Access Compliance Report

Public Rights-of-Way

(Curb Ramps)

Intersection ID: 47840	Main Street: PECO_RD	Cross Street: CACTUS_VALLEY_RD	Location: SE
ADA ID: AE6AF81A2845	Ramp Type: Perp	Initial Pass/Fail: Fail	Overall Compliance: No
Severity Score: 21.25			
Codes/Mitigation Info/Possible Solution		Field Measurements/Component Compliance

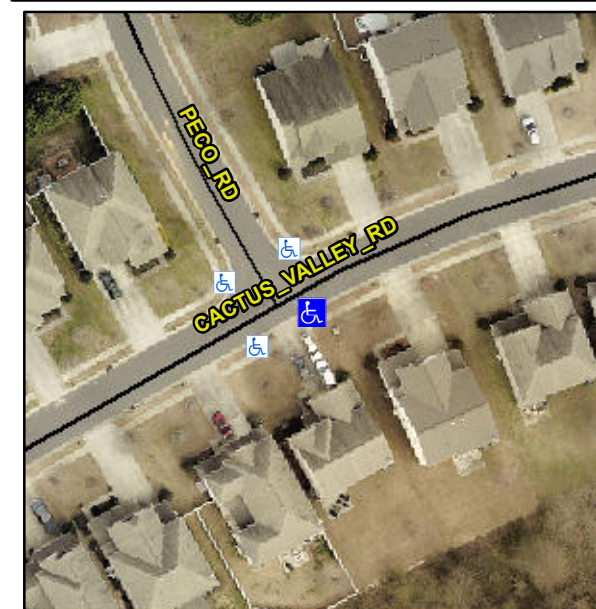
Not Found, R304.5.1, R304.2.2

Compliance	Description	Data	Compliance	Description	Data
N/A	Ramp Length (in)	49.0	No	Ramp Slope (%)	9.2
No	Ramp Width (in)	45.5	Yes	Ramp XSlope (%)	2.0
N/A	Flare Type LT	N/A	N/A	Flare Type RT	N/A
N/A	Flare Slope LT (%)	N/A	N/A	Flare Slope RT (%)	N/A
N/A	Flare Traversable LT?	N/A	N/A	Flare Traversable RT?	N/A
N/A	Landing Length (in)	N/A	N/A	DWS Provided?	N/A
N/A	Landing Width (in)	N/A	N/A	DWS Contrast?	N/A
N/A	Landing Slope (%)	N/A	N/A	DWS Length (in)	N/A
N/A	Landing X Slope (%)	N/A	N/A	DWS Full Width?	N/A
N/A	Landing Curb? (Y/N)	N/A	N/A	DWS Offset (in)	N/A
N/A	Shared Landing?	N/A			
N/A	Gutter Ponding?	N/A	N/A	Gutter Slope (%)	N/A
N/A	Gutter Lip Ht (in)	N/A	N/A	Gutter X Slope (%)	N/A
N/A	Painted X Walk1?	No	N/A	Painted X Walk2?	N/A
	X Walk 1 Direction	To NW		X Walk 2 Direction	N/A
N/A	X Walk 1 Width (in)	N/A	N/A	X Walk 2 Width (in)	N/A
	X Walk 1 Slope (%)	2.9		X Walk 2 Slope (%)	N/A
	X Walk 1 X Slope (%)	1.6		X Walk 2 X Slope (%)	N/A

Remove & Replace Entire Ramp.
